DESIGN REVIEW: Aegis West Seattle

FEBRUARY 4, 2016

DPD NUMBER: 3017747

ITEMIZED RESPONSE TO EDG

DEPARTURES: NON-ALLEY ACCESS TO PARKING GARAGE & LOADING

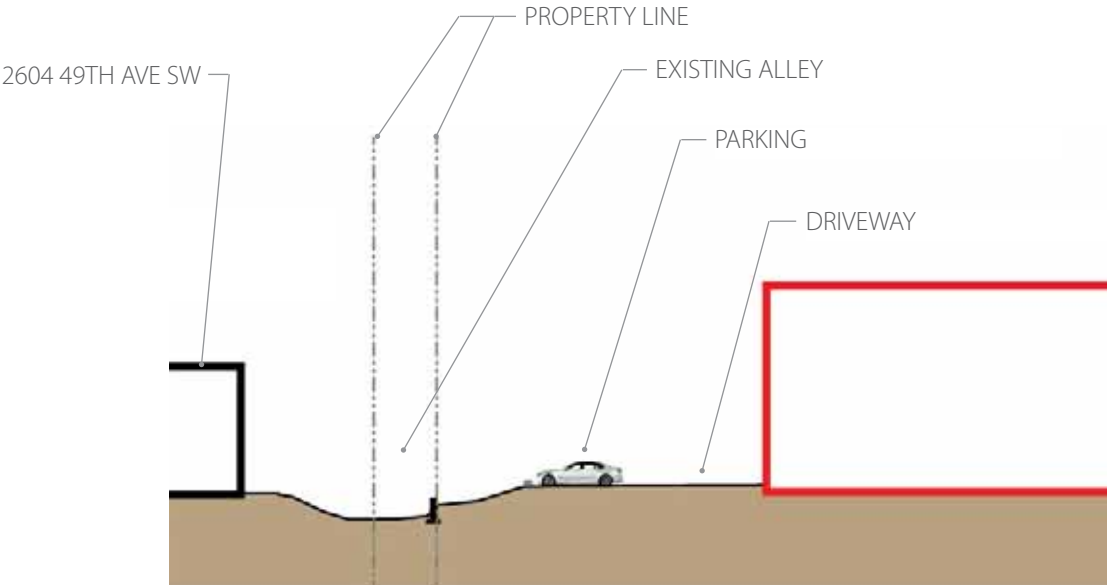
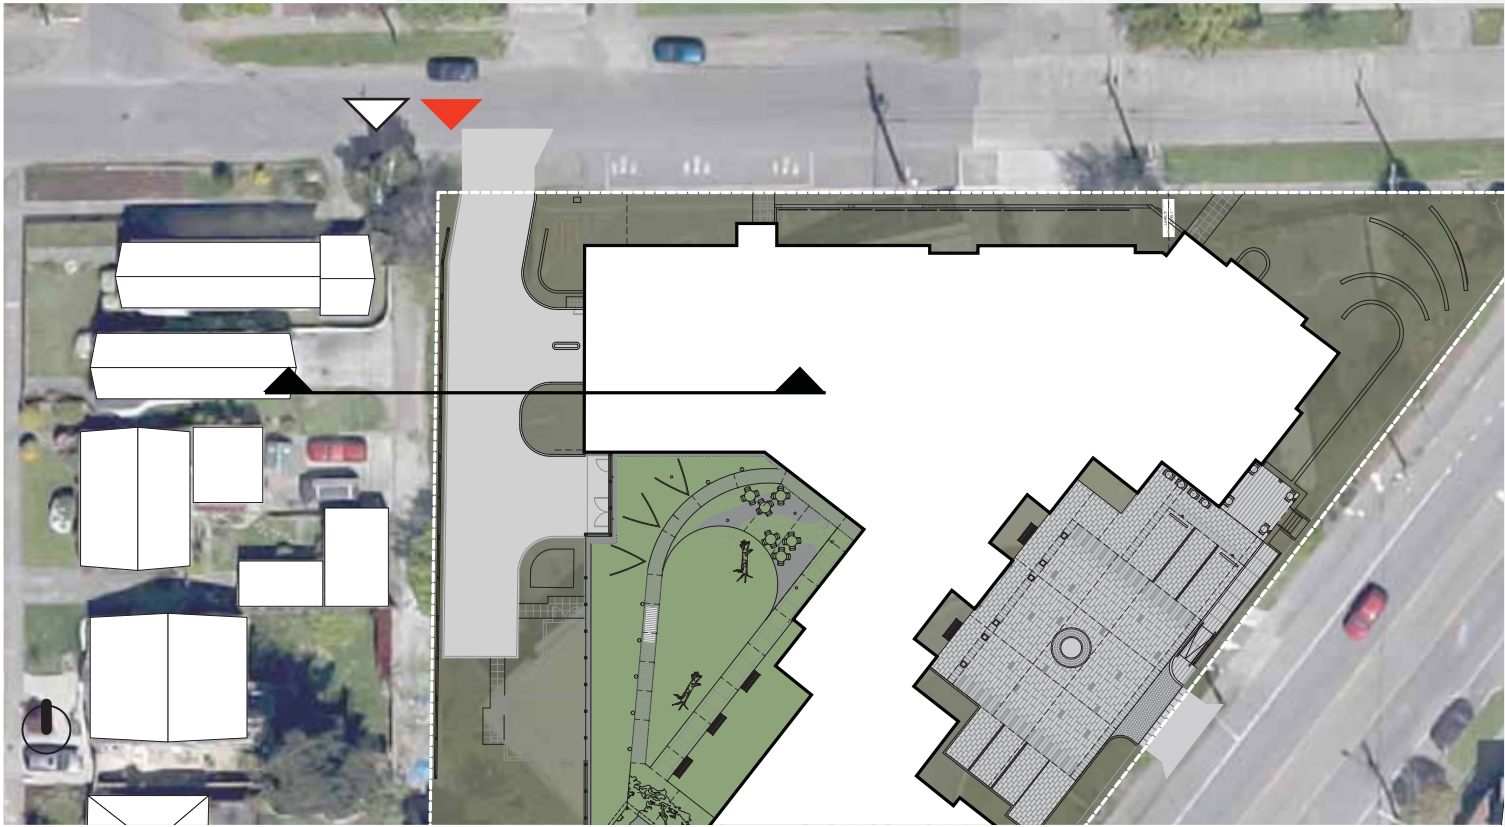
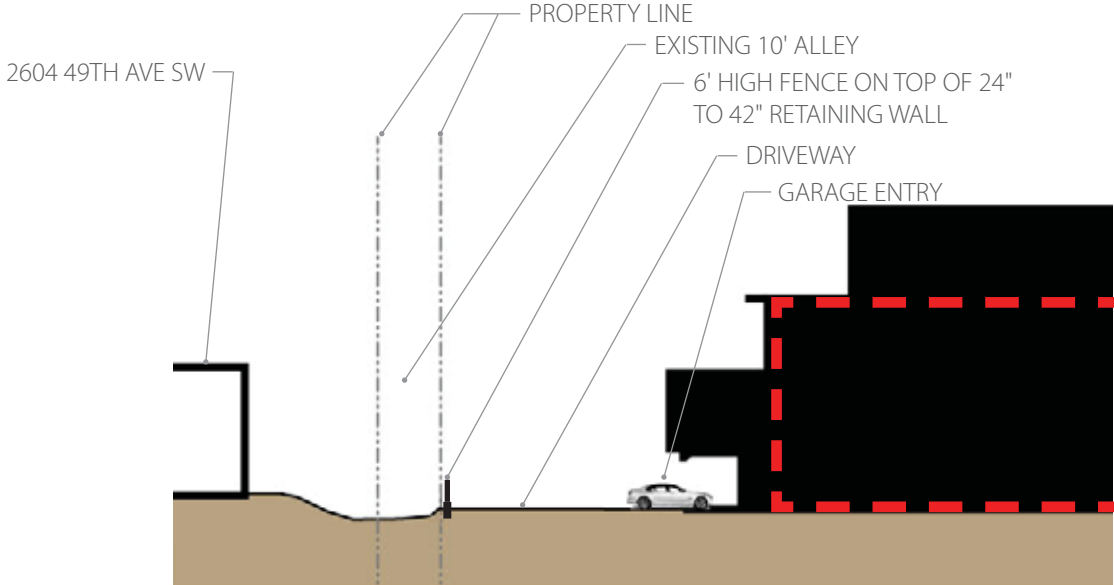
EDG Board Comments
NEW DEPARTURE; CONCEPT DISCUSSED AT EDG MEETING
(Related to Driveway Slope Director's Approval request and Driveway Development guidance)
